**MEMORANDUM**

**Job 10740**

**To:** Jade McRae  
**From:** Victroia Jones and Hamish Lowe, LEI  
**Date:** 6 September 2022  
**Subject:** Request for Further Information on Resource Consent Application - APP-20222055

**Appendix B  
Updated DESC**

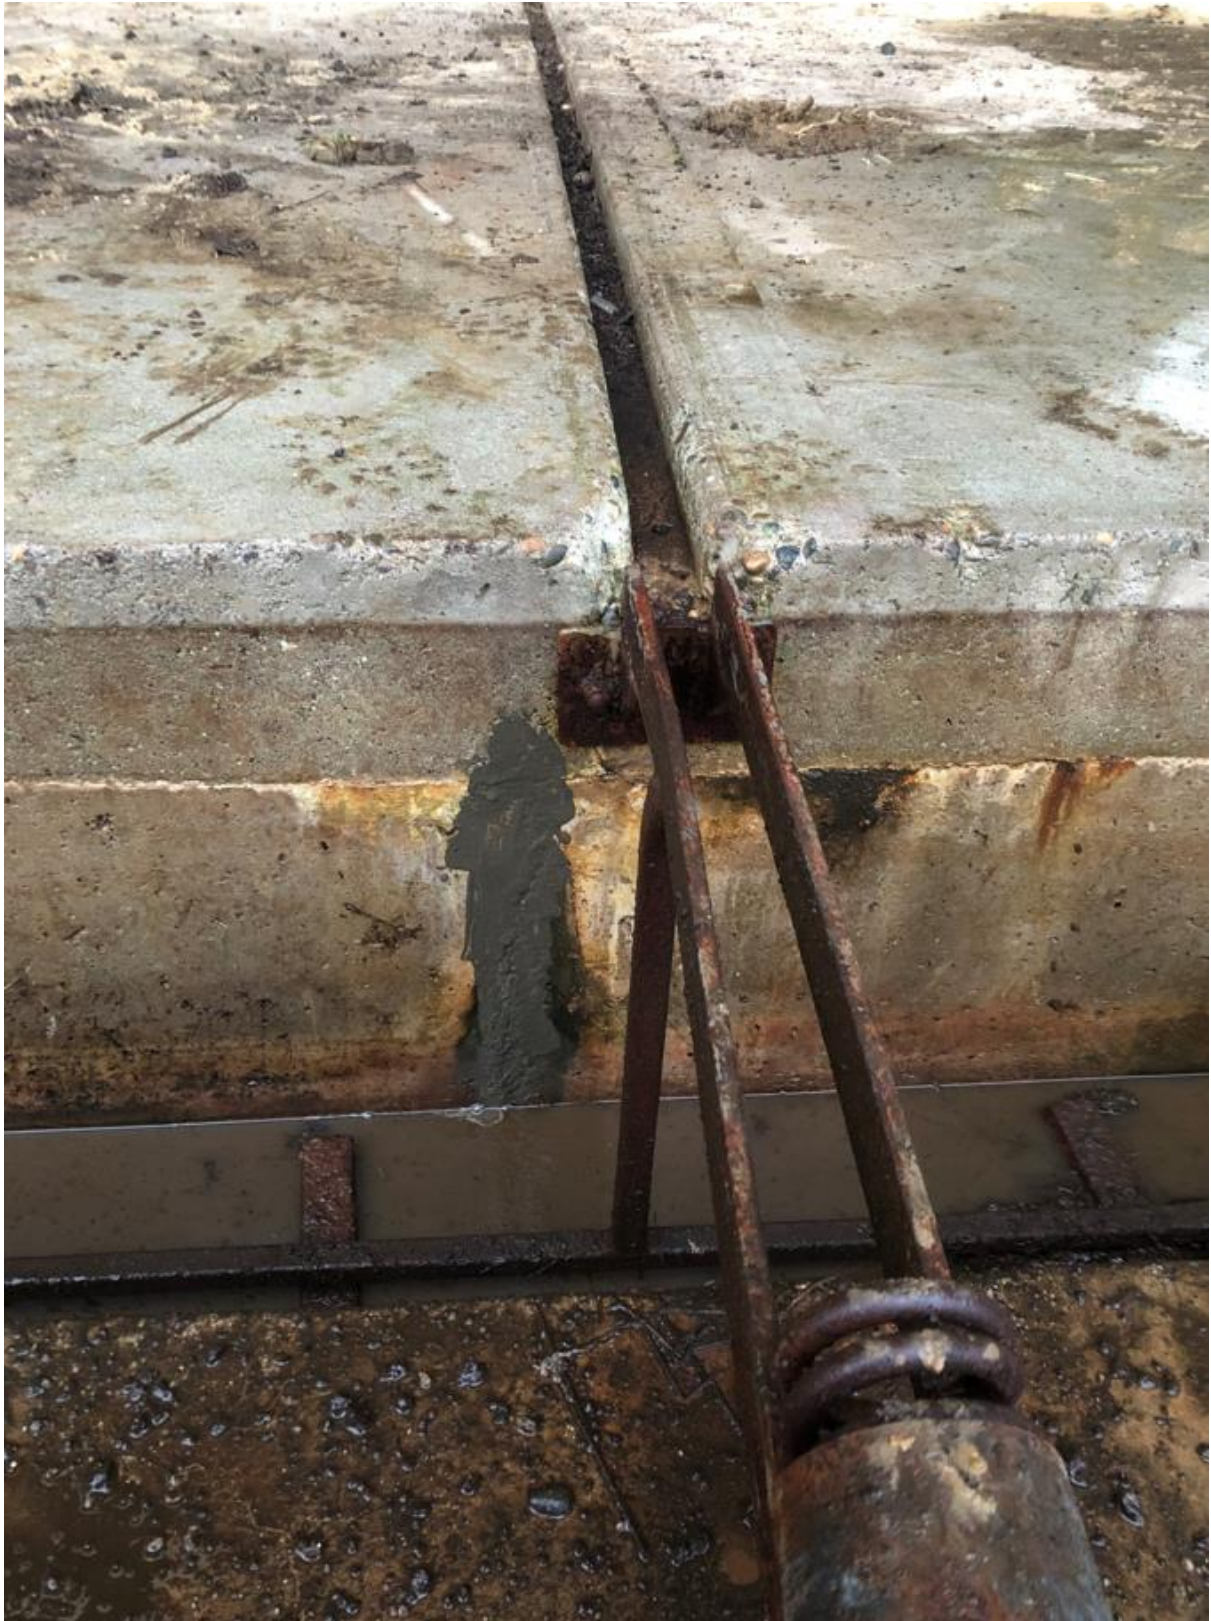
8. Confirmation of the size of the proposed winter barn. I am requesting this information because the main application document and DESC specify  $4,590\text{m}^2$  (current barn) +  $3,650\text{m}^2$  (new barn) =  $8,240\text{m}^2$  combined but the Part B form says  $4,590\text{m}^2$  (current barn) +  $4,380\text{m}^2$  (new barn) =  $8,970\text{m}^2$  combined.

Response: Sorry this was a mistake as the estimated barn size changed part way through the application. The correct size is current barn (4,590 m<sup>2</sup>) + new barn dimensions being 36.5 m x 120 m (4,380m<sup>2</sup>) (as mentioned in Section 4.3 of the application) = 8,970 m<sup>2</sup> combined. I note 8,240 m<sup>2</sup> has been used in the DESC, but again this is a mistake. However, this won't affect the DESC as the rainwater is diverted as the barns are covered. I have attached the DESC below in Appendix B to show there has been no change in required effluent storage.
